Subject: Almond 2 Power Plant (09-AFC-02)
Staff Query Set 2, Responses to CEC Staff Queries 2 and 3

Staff Queries, Set 2
(Responses to Staff Queries 2 and 3)

Almond 2 Power Plant

(09-AFC-2)

Notice Criteria Tool

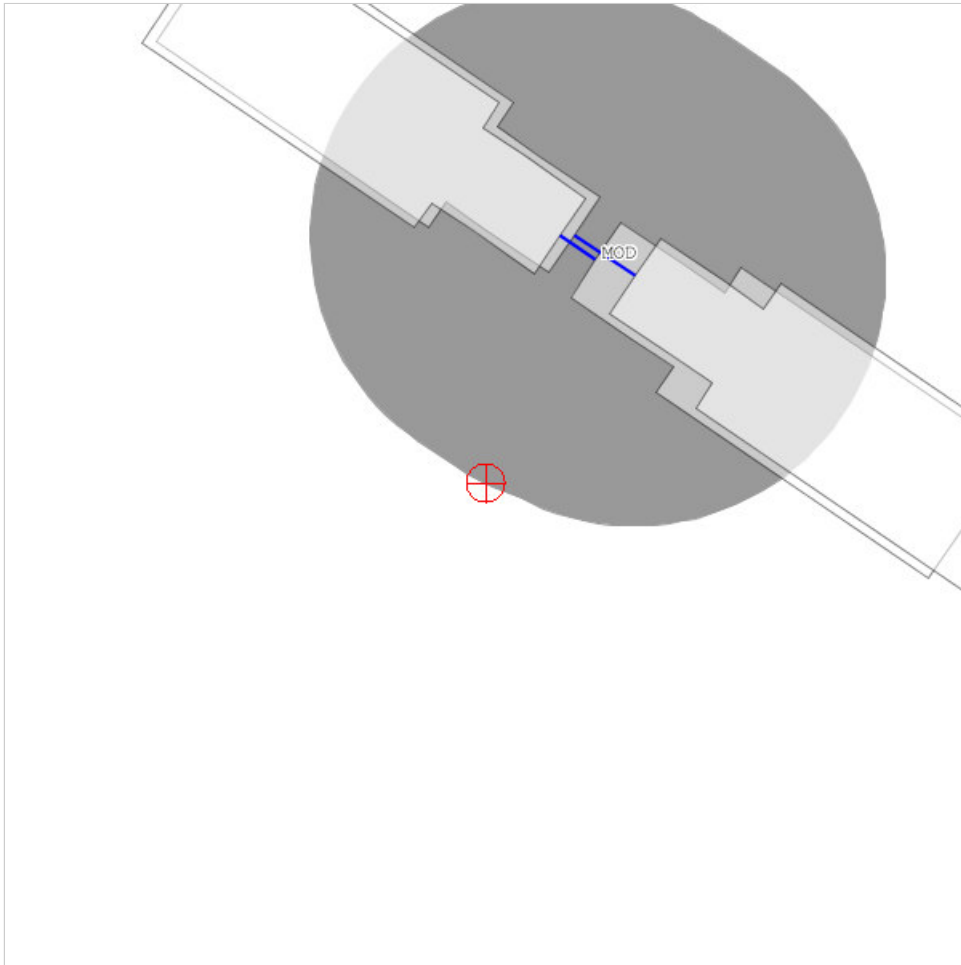
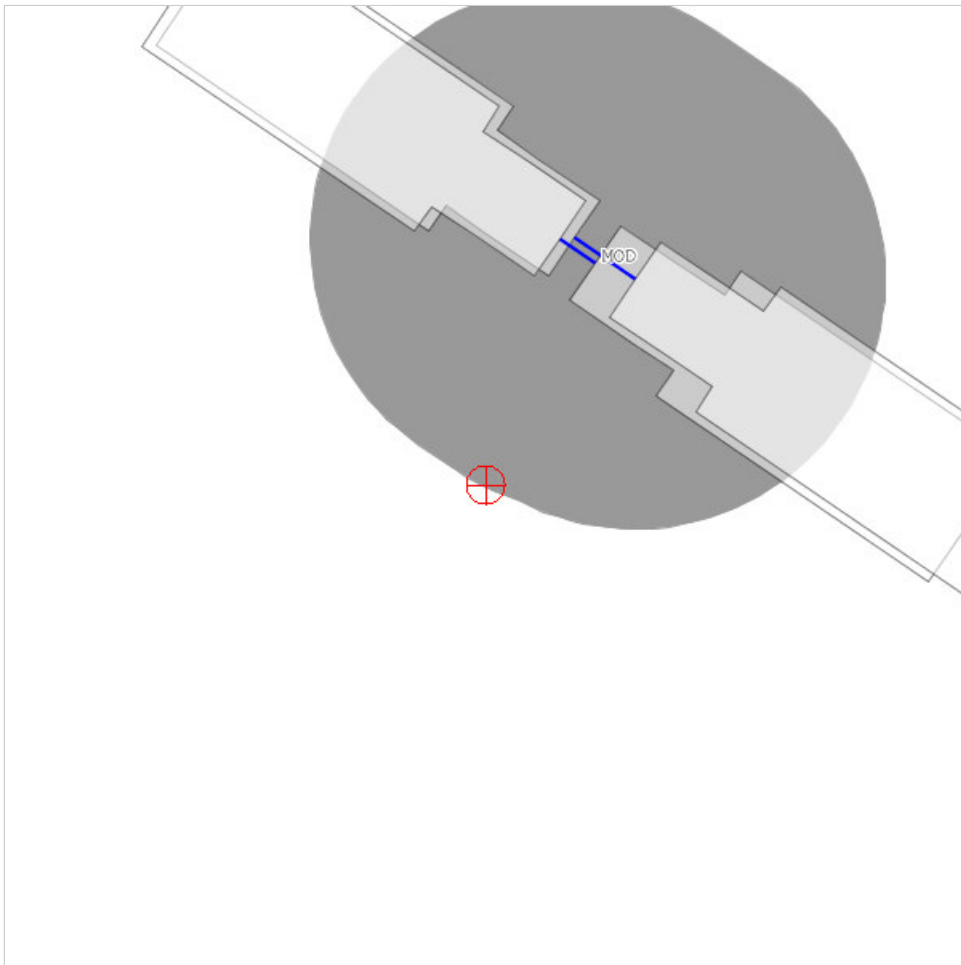
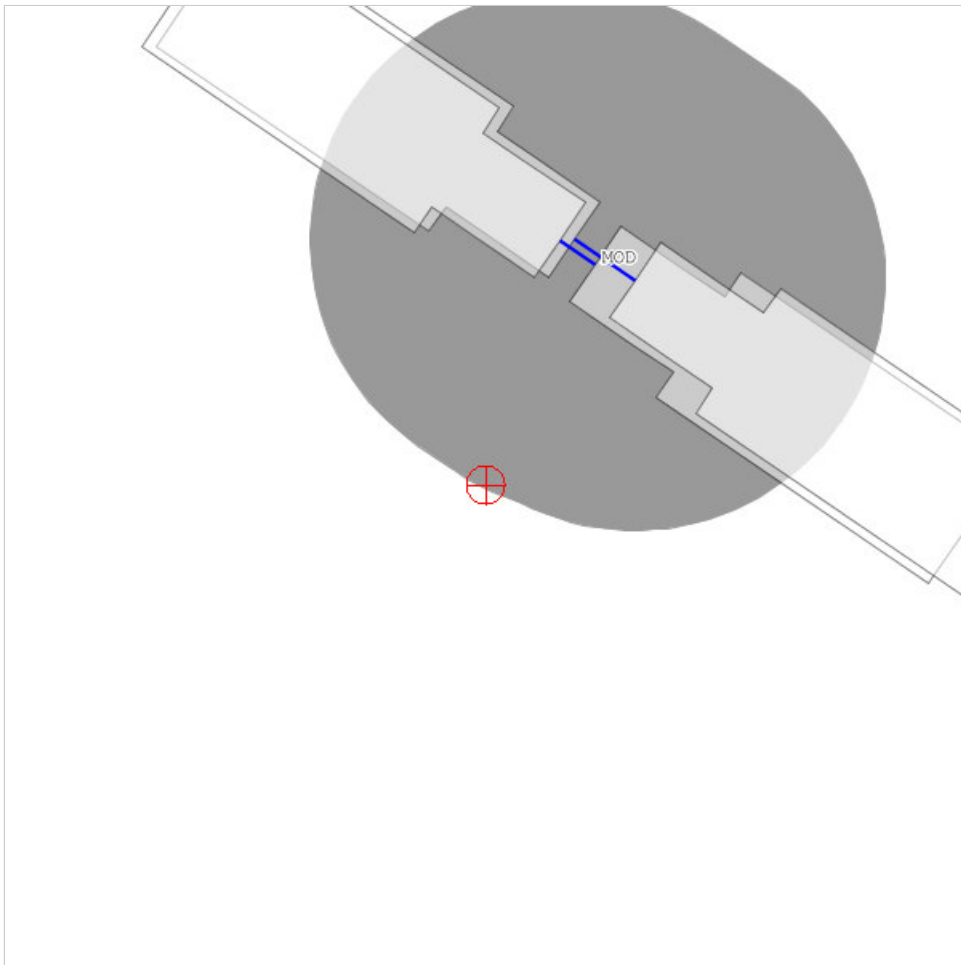
SQ-3. Is an FAA Form 7460-1, Notice of Proposed Construction or Alteration, required for the A2PP?**Response:** The requirements for filing a FAA Form 7460-1, Notice of Proposed Construction or Alteration with the Federal Aviation Administration is based on the following five items as identified in 14 CFR 77.13. A discussion of the A2PP status as it relates to these five items follows.

2. *The structure will be in proximity to an airport and will exceed the slope ratio*
 - The slope ratio is calculated by the FAA Notice Criteria tool². As discussed in Section 3.4.3 of the AFC, a FAA Notice Criteria evaluation was performed to determine if a FAA Form 7460-1, Notice of Proposed Construction or Alteration, was needed. Appendix 3A of the AFC provides a copy of the Notice Criteria evaluation tool for a point located near the center of the site. An additional evaluation for the three stacks was performed using the FAA Notice Criteria tool to determine if any of the three stacks exceeded the slope ratio. Attachment SQ3-1 provides a copy of the FAA Notice Criteria tool for each of the three stacks, which states the Notice Criteria has not been exceeded.

1. *The structure exceeds 200ft above ground level*
 - The three stacks at the A2PP are 80 feet in height at an elevation level of 81.6 feet, and therefore do not exceed the 200 foot requirement.

Based on the discussion above, a FAA Form 7460-1 is not needed for this project.
